MEMORANDUM

DATE: March 26, 2021

SUBJECT: ZC Case No. 20-08 – Howard University Campus Plan

Figure 2. Existing and Proposed Vehicle and Loading Access (Source: Grove Slade, December 2020 CTR, Table Figure 21)

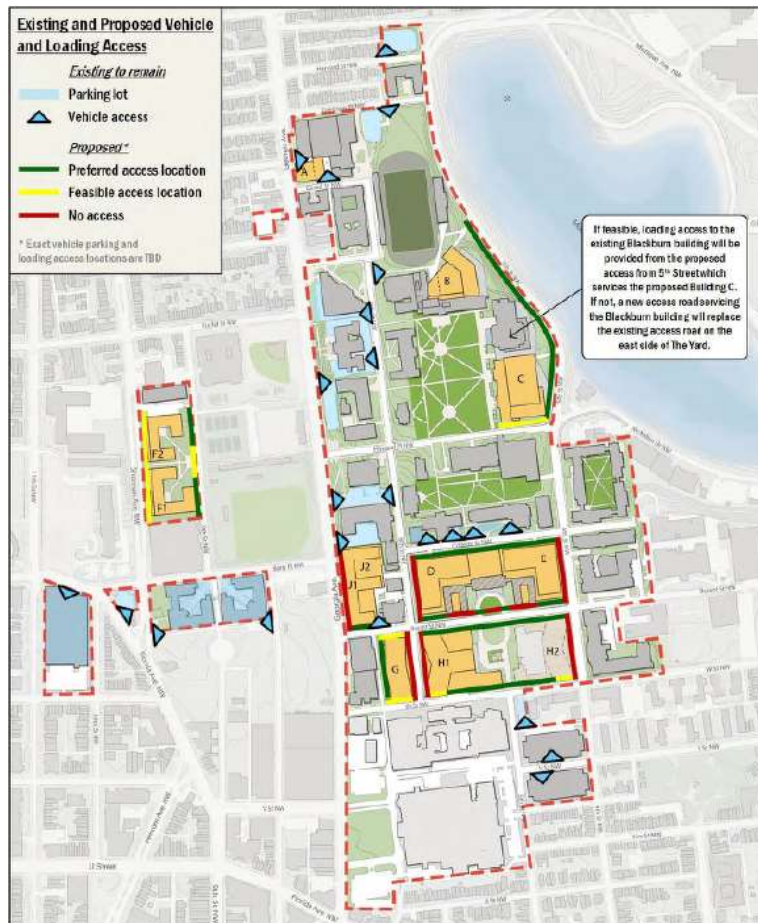
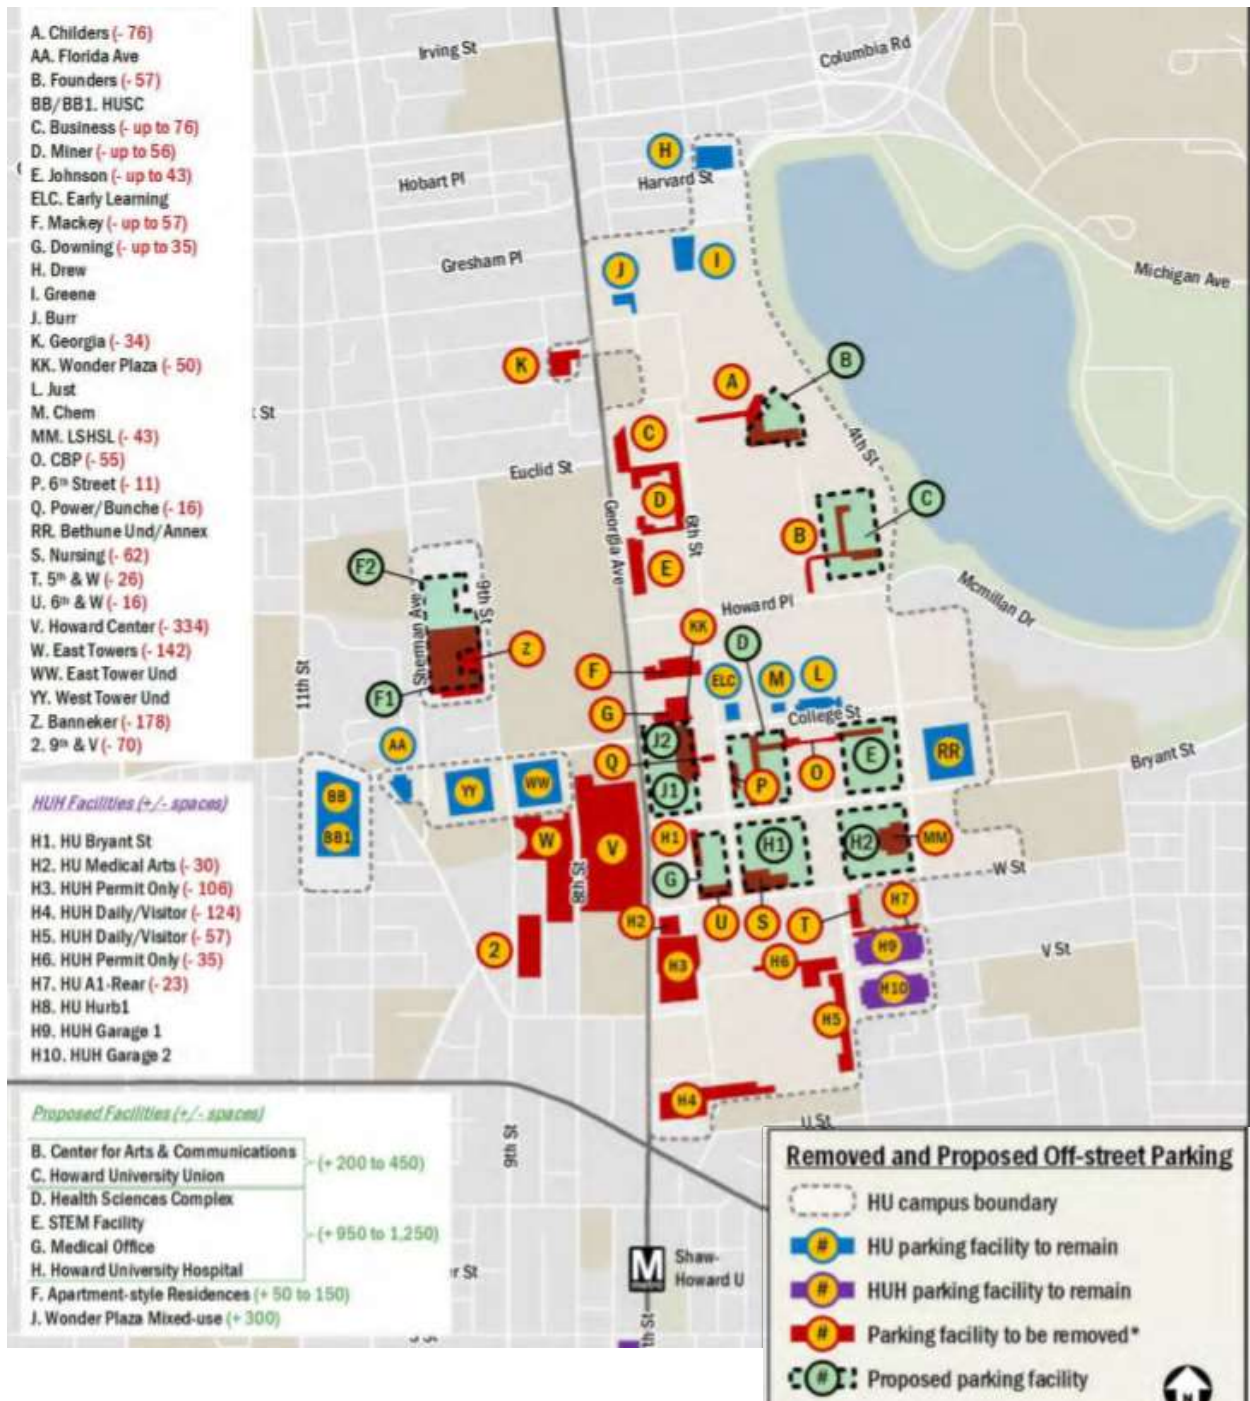
- DDOT does not support vehicle access off of 5th Street NW along the McMillan Reservoir as this road has several sight distance concerns due to its curvilinear nature;

Figure 2 outlines proposed locations of loading and vehicle access. DDOT does not support access off of 5th Street NW and 4th Street NW along the McMillan Reservoir as this road has several sight distance concerns. Currently the plan proposes potential parking and loading access 5th Street NW at buildings B and C and DDOT recommends the Applicant propose access internally, such as along Howard Place NW.
